**Report: TAB Remarks**  
**Function: Test, Adjust, & Balance**  
**Date: 03/31/2026**  
**Completed By: National TAB**

## Moxies Restaurant (Fort Lauderdale, FL)

## Issue List

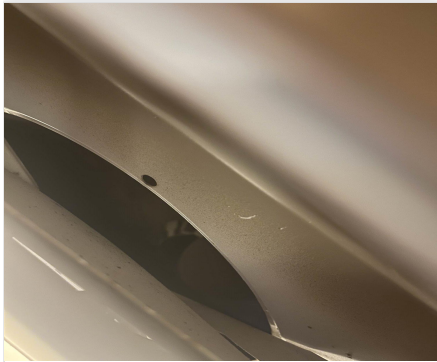
**Issue Name :** AHU 1-4 Diffuser not fully connected  
**Description :** Duct is not properly connected to the diffuser and leaking air above ceiling.  
**Created By :** National TAB                      **Assigned To :** National TAB - Joe Hertenstein  
**Status :** Open  
**Priority :** High                                      **Asset Tag :**  
**Originated Date :** 04/02/2026 - Tyler Youells - National TAB

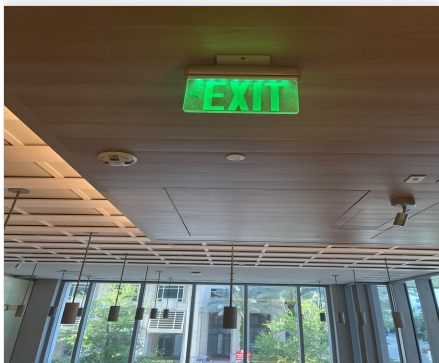
**Issue Name :** AHU 2-3 Compressor Cycling  
**Description :** AHU 2-3 Compressor is cycling on for 15-30 Seconds and then shutting off and then back on which is not normal, the unit is not displaying any alarms. recommend Service tech evaluates system cooling.  
**Created By :** National TAB                      **Assigned To :** National TAB - Joe Hertenstein  
**Status :** Open  
**Priority :** High                                      **Asset Tag :**  
**Originated Date :** 04/01/2026 - Tyler Youells - National TAB

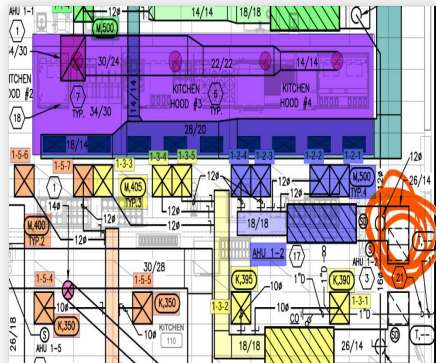
**Issue Name :** Air filters need to be changed  
**Description :** air filters are well pass the change date, particularly in the kitchen.  
Recommend replacing all filters  
**Created By :** National TAB      **Assigned To :** National TAB - Joe Hertenstein  
**Status :** Open  
**Priority :** Medium      **Asset Tag :**  
**Originated Date :** 03/31/2026 - LAURA CUESTA - National TAB

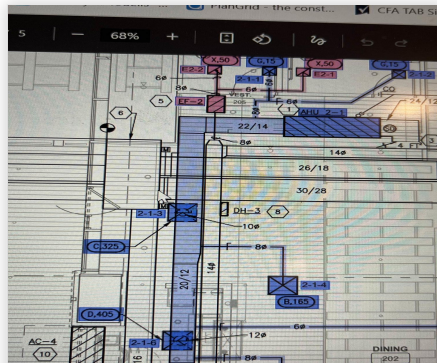
**Issue Name :** MUA-1 Flow/Choke Point  
**Description :** MUA total flow is 4850/8136CFM. Suction pressure at inlet of the unit is -2.30" indicating restriction. Tracing duct restriction is found at damper through demising wall. Duct goes from 30/28 down to 20/16 damper which is not even the free area. Prints were not followed in regards to Keynote 6

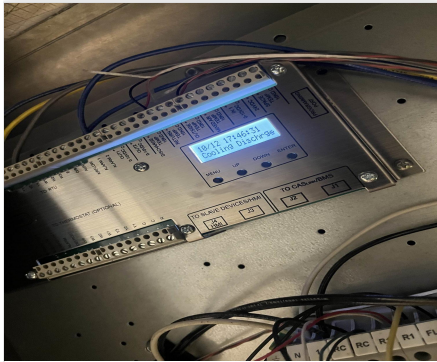
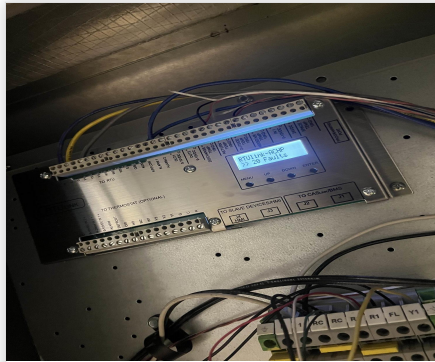
**Issue Name :** MUA-2 Cooling alarm  
**Description :** MUA-2 has 20 alarms all for cooling discharge. Recommend servicing cooling system of the unit.  
**Created By :** National TAB                      **Assigned To :** National TAB - Joe Hertenstein  
**Status :** Open  
**Priority :** Medium                                      **Asset Tag :**  
**Originated Date :** 04/01/2026 - Tyler Youells - National TAB
